ADDENDUM NO 1

2011 Water System Expansion
Highway 190 Ground Storage Tank
Contract No. 12-1475-12

Ward Two Water District

November 7, 2012

PROJECT: 2011 WATER SYSTEM EXPANSION
 CONTRACT: 12-1475-12
 SHEET: AS-0200
 SCALE: AS SHOWN
 PROJECT: 1475122 TASK 03
 LIVINGSTON PARISH, LOUISIANA
 WARD TWO WATER DISTRICT
Owen
 ENGINEERING & ARCHITECTURE
 1000 W. MONROE ST. SUITE 100
 MONROE, LA 70001
 (504) 281-1111

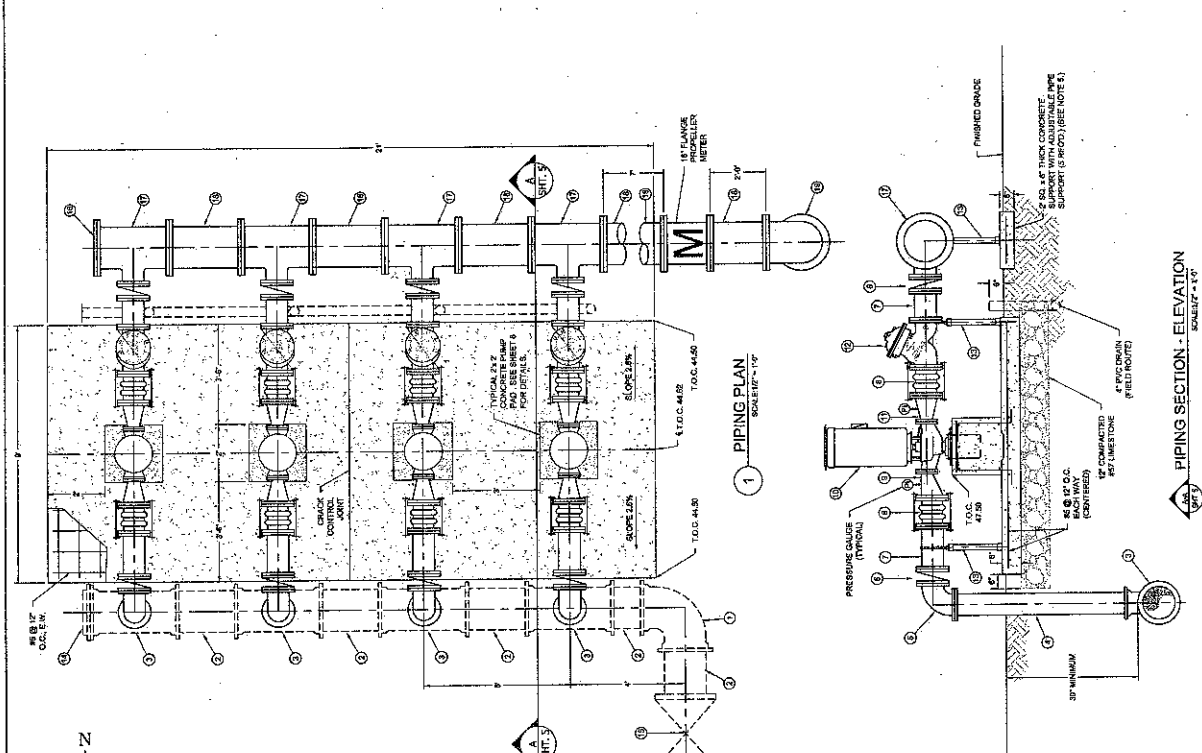
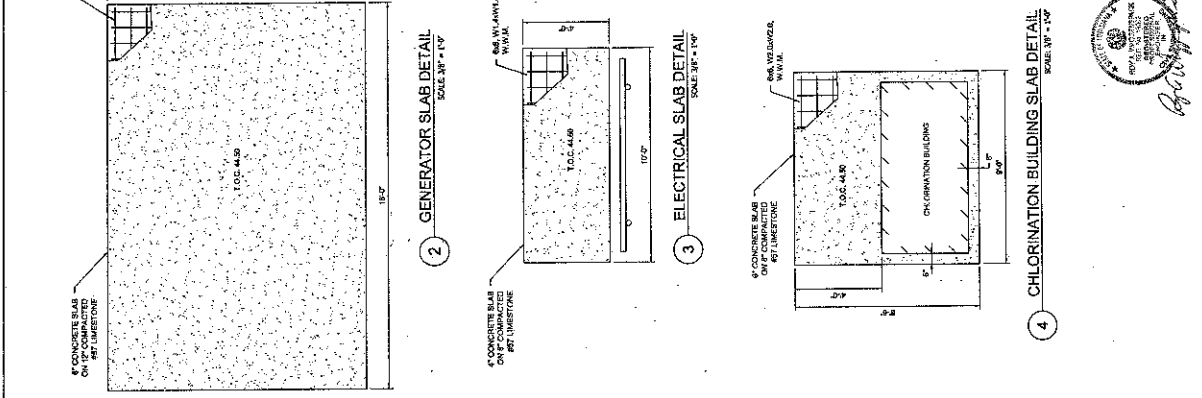
Sheet 5 – The discharge header has been revised from below ground (buried pipe) to above ground. Replace Sheet 5 with the attached revised Sheet 5.
